Cundy Street Quarter

Transport Assessment Addendum

Transport Assessment Addendum

23/10/2020

FIGURE 2.1
PARKING RELOCATION STUDY

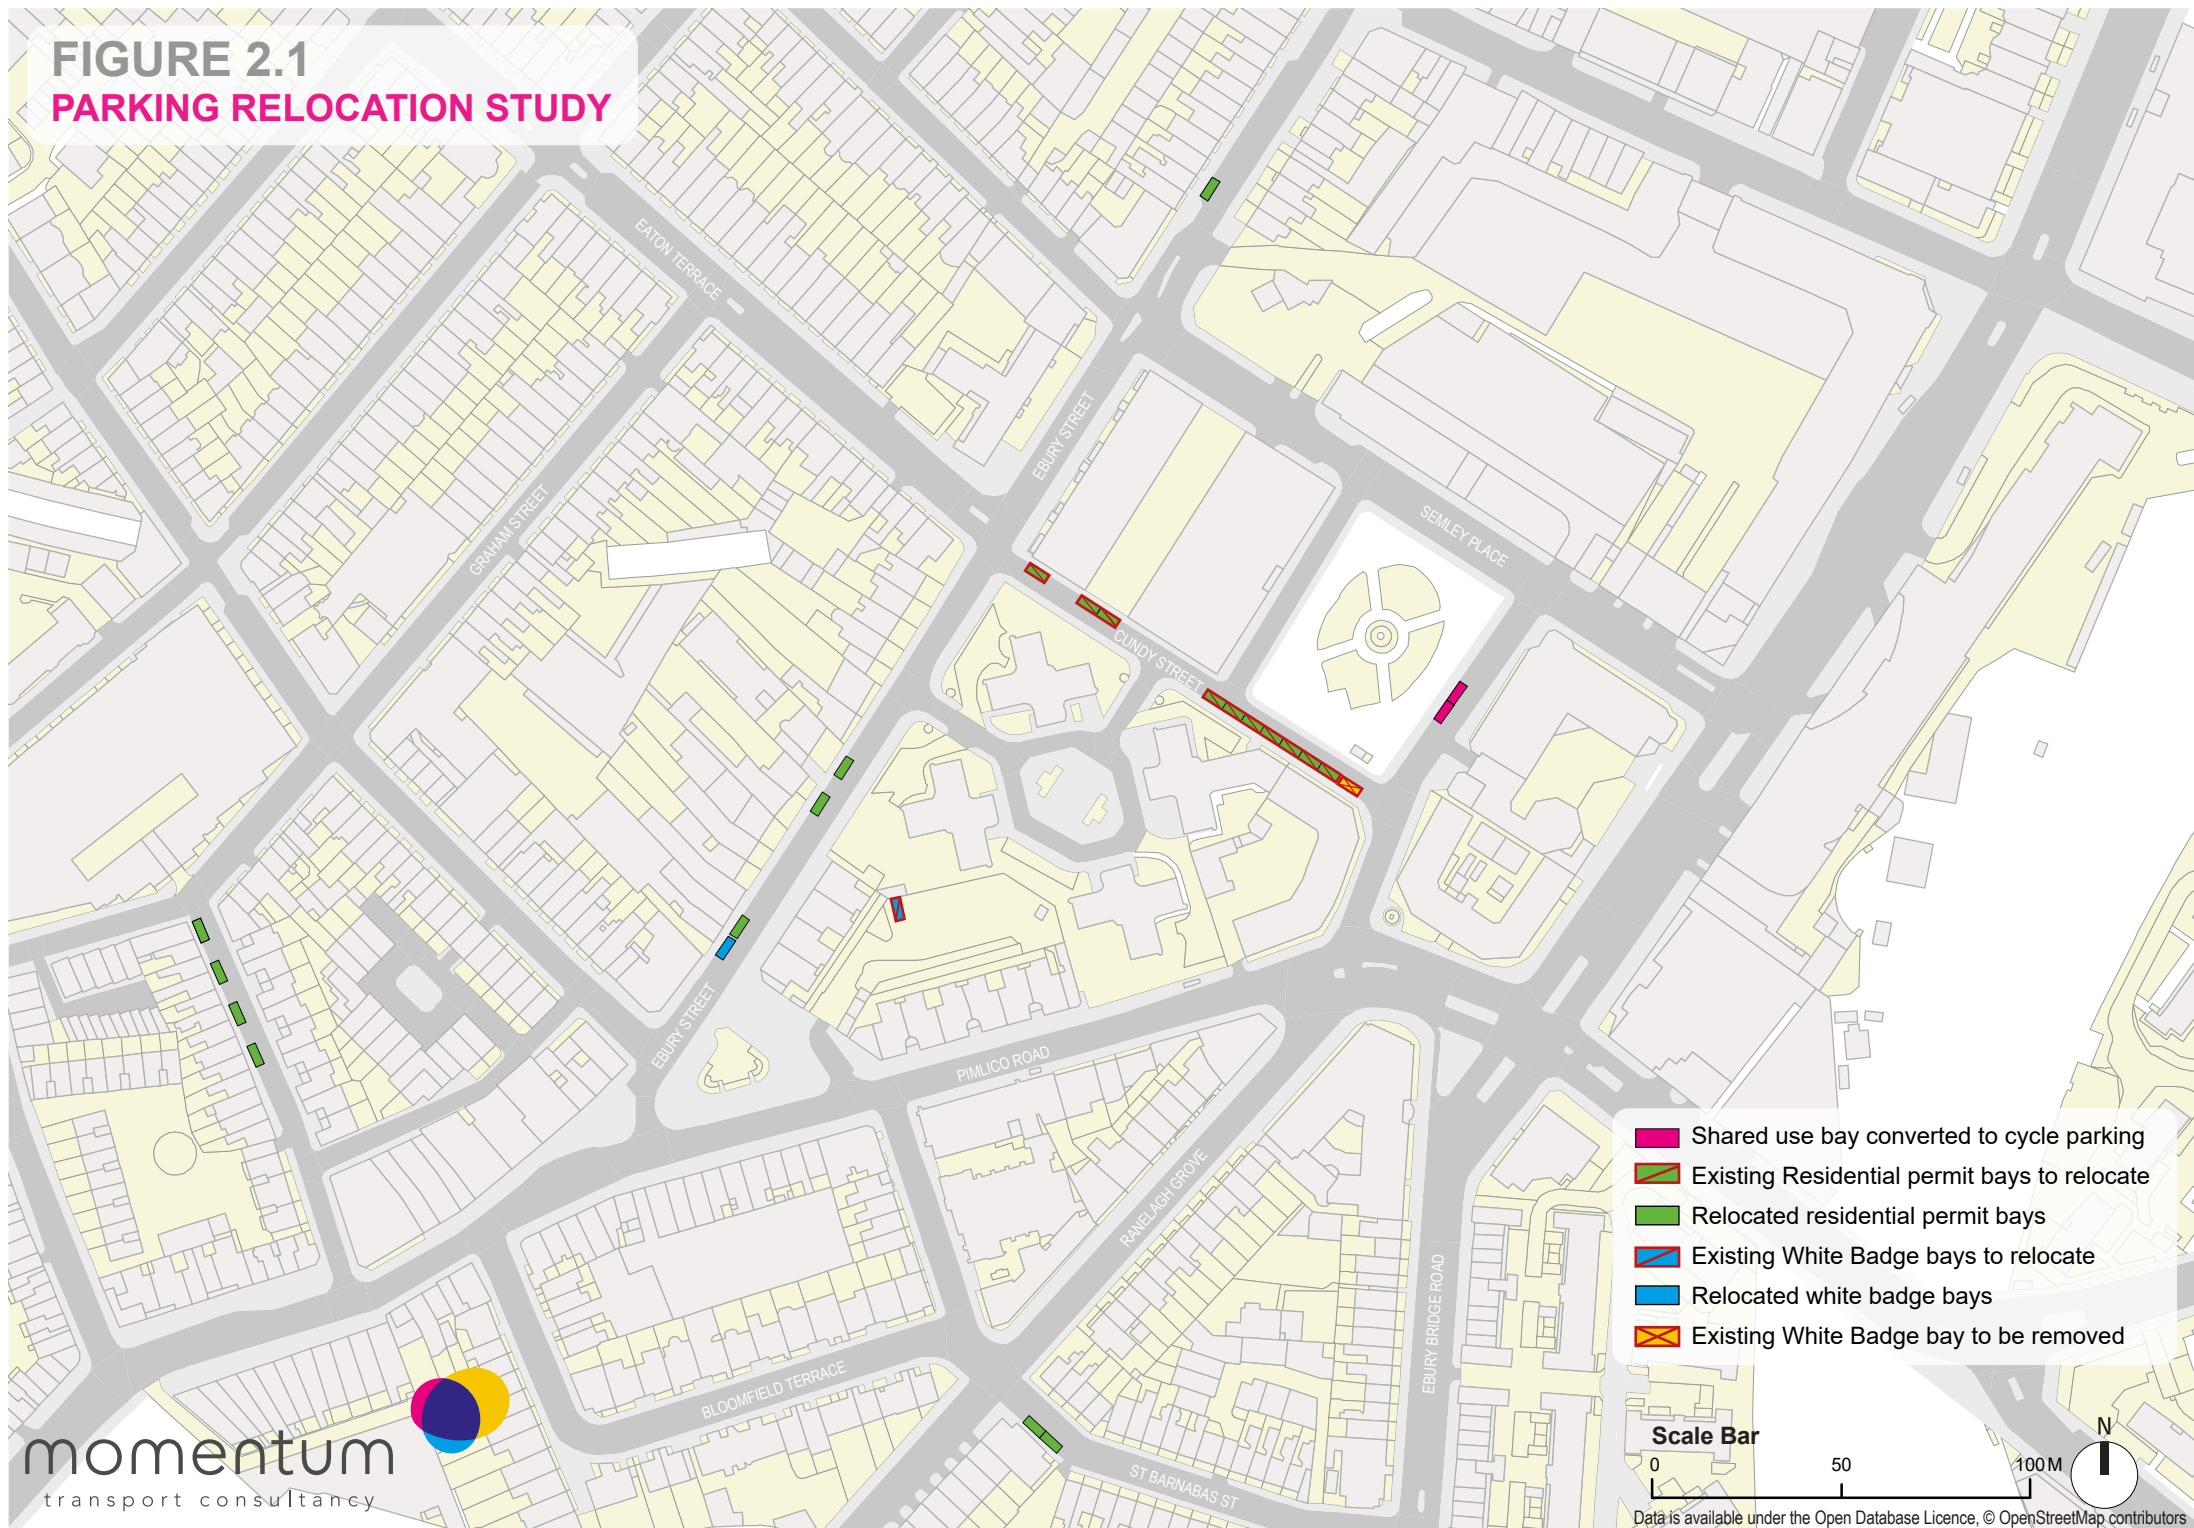
2.2.5 Figure 2.1 shows the indicative single yellow line locations identified for the relocation of the three (3) residential parking bays from Cundy Street and seven (7) residential parking bays from the southern section of Ebury Square. It is acknowledged that these amendments would need to be approved at a later stage. However, the analysis shows that there are suitable alternative locations also available to address the relocation strategy.

2.2.6 The revised on-street parking relocation strategy can therefore be summarised as follows:

- Relocate seven residential permit holder bays from the southern Section of Ebury Square to single yellow line locations within 450m of their original locations. These spaces would be removed to facilitate increased footway width on the southern footway on the southern section of Ebury Square;

- Relocate three residential permit holder bays from Cundy Street to single yellow line locations within 450m of their original locations. These spaces would be removed to provide a safer environment for cyclists and motor vehicles and improved access to the Building A drop-off and servicing yard;

FIGURE 5.2
REVISED SHORT STAY CYCLE PARKING

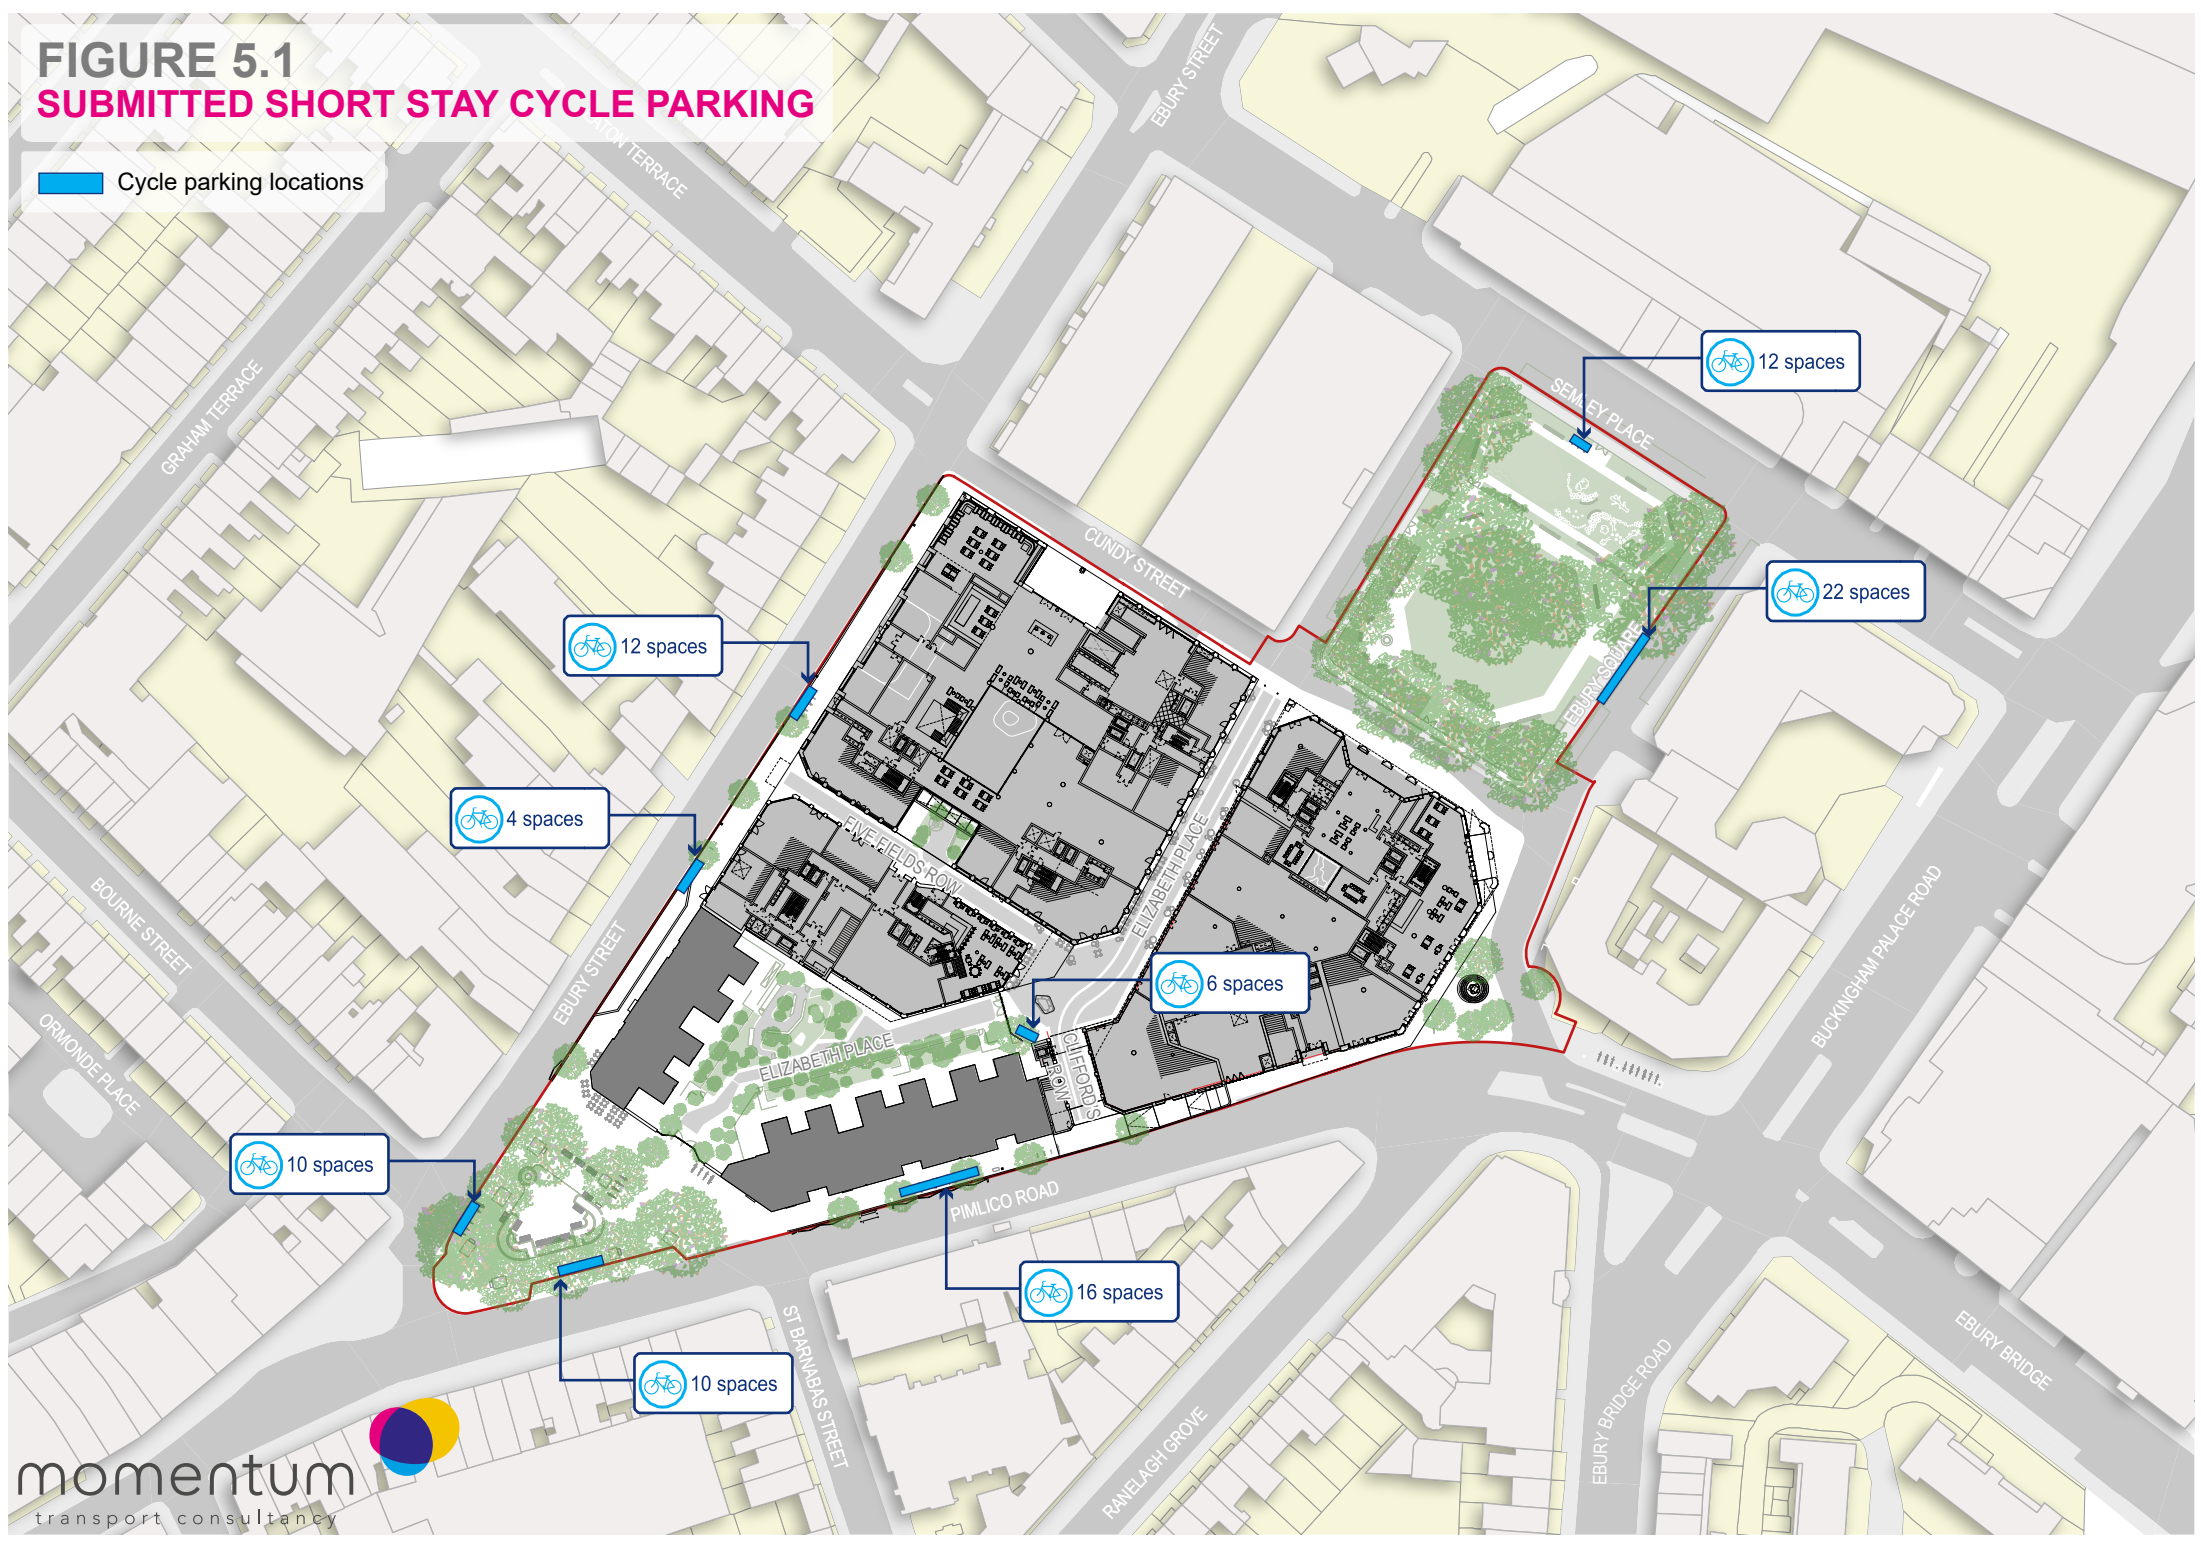
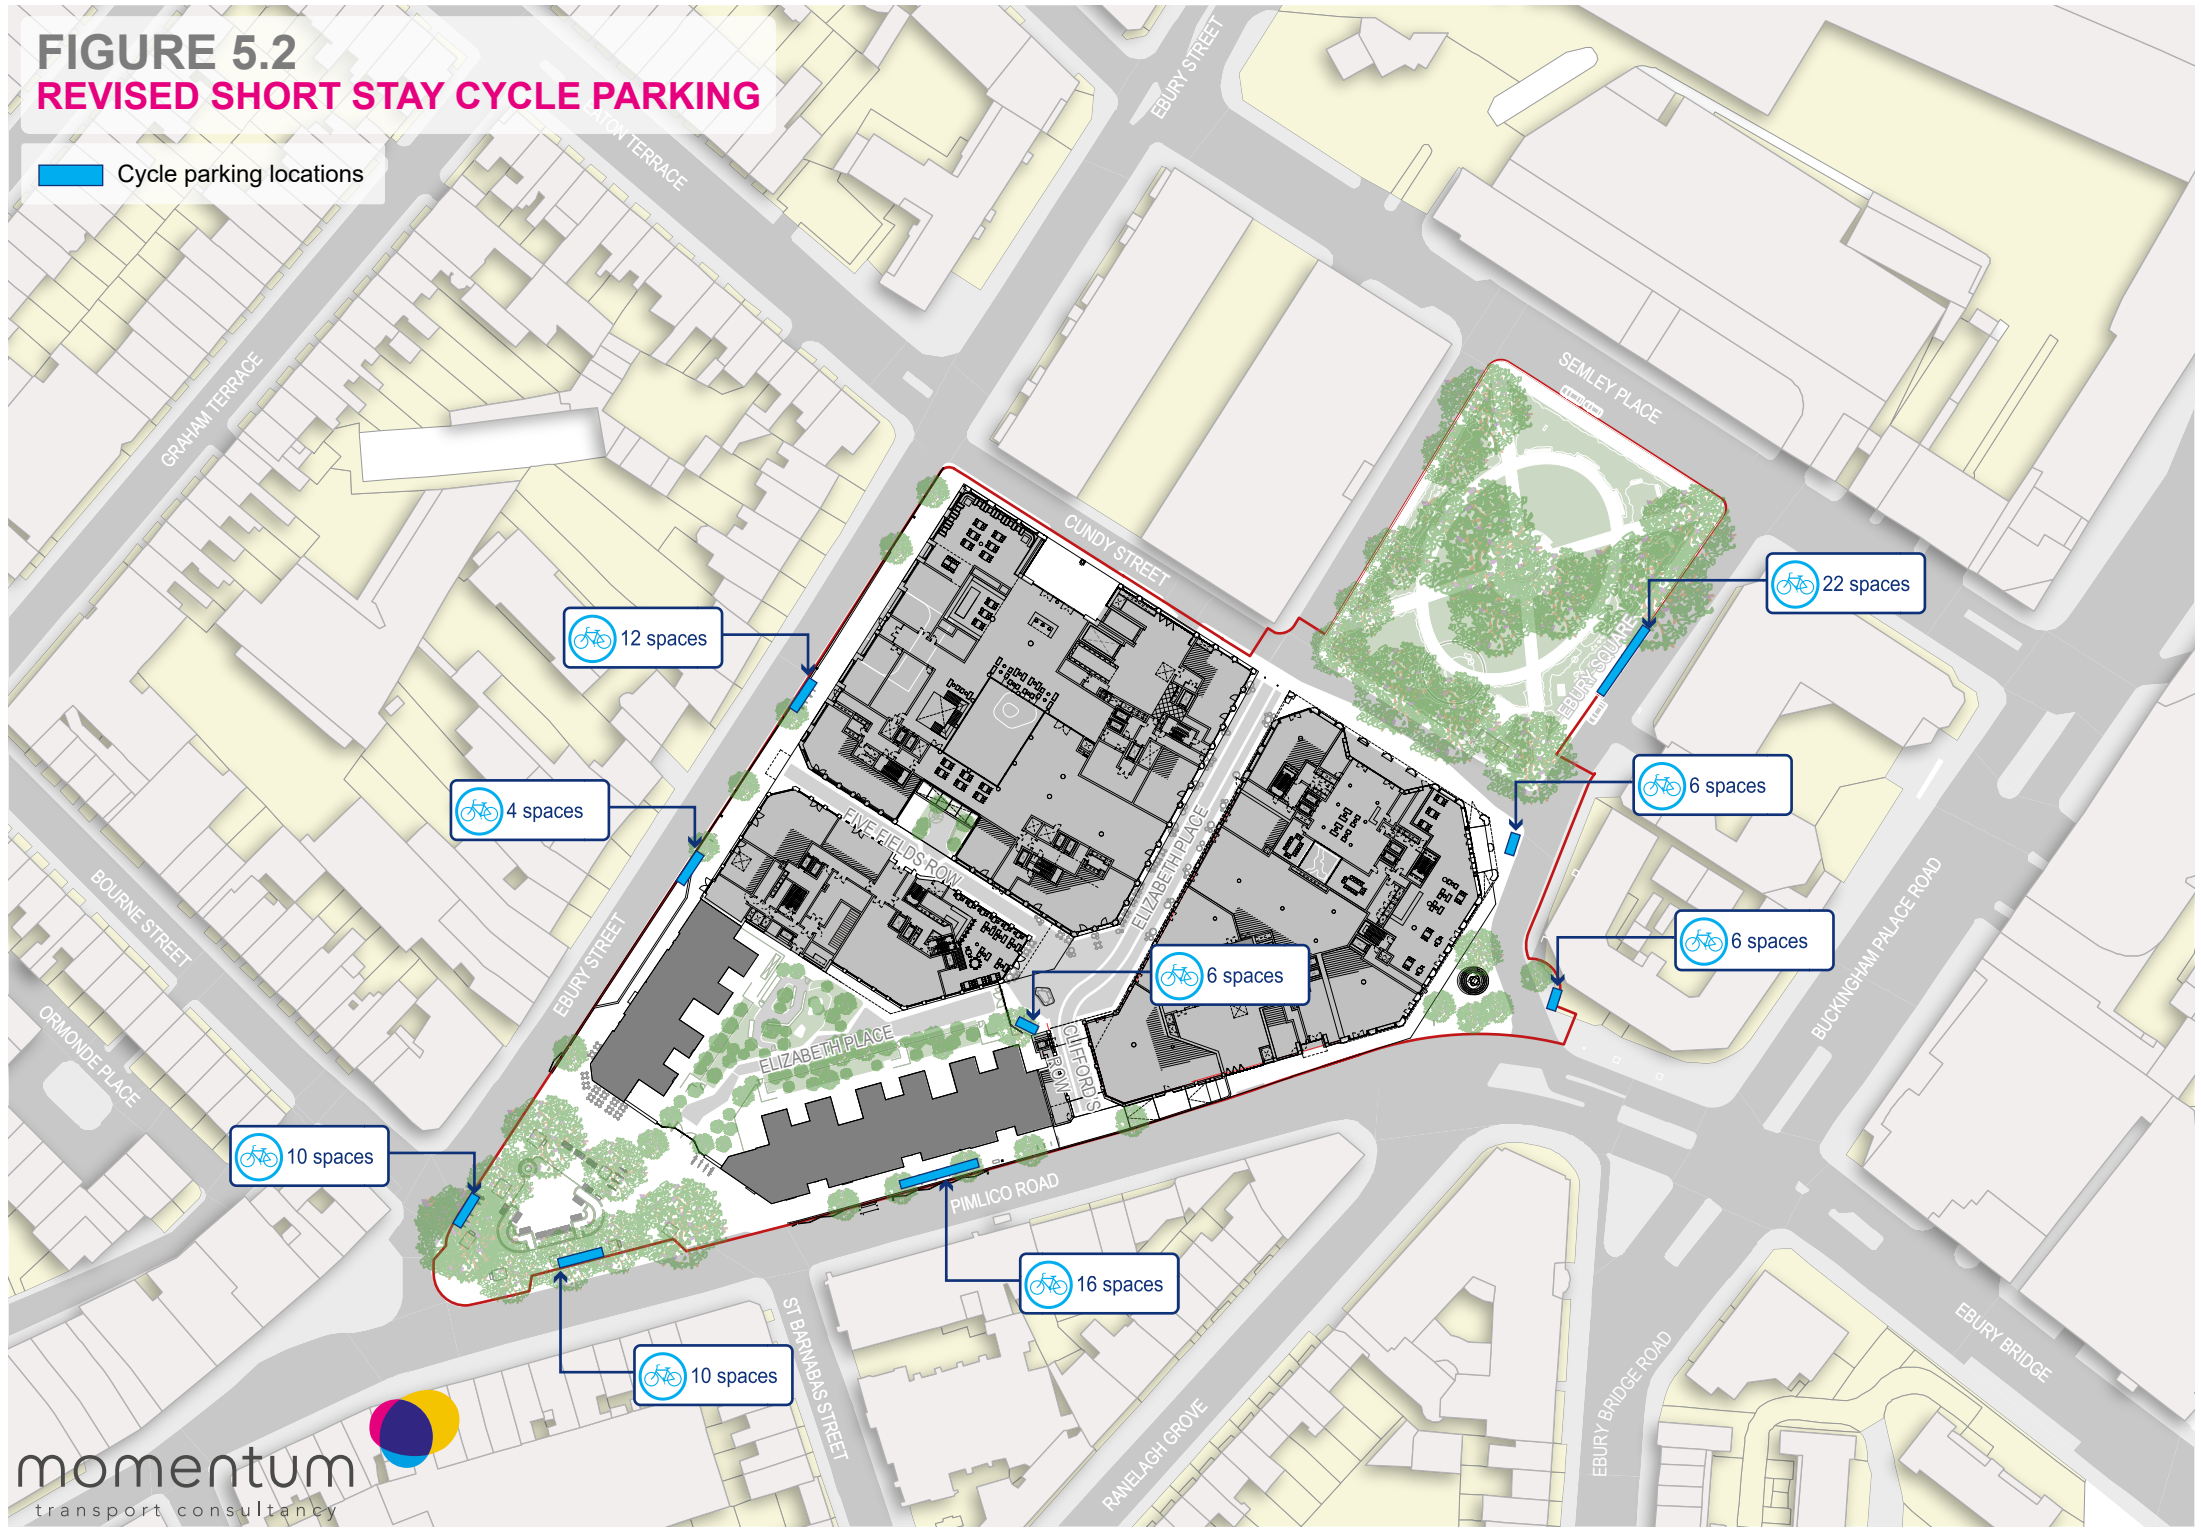
- 5.3.6 Figure 5.1 outlines the submitted location of the proposed short-stay cycle parking locations, whilst Figure 5.2 outlines the revised location of the proposed short-stay cycle parking.
- 5.3.7 As discussed during a meeting with WCC Highways on Thursday 1st October, it has not been possible to further increase the provision of short-stay cycle parking within the Site due to the fire escape and without impacting on pedestrian comfort levels. However, 12 short-stay cycle parking spaces have been relocated closer to the Site.
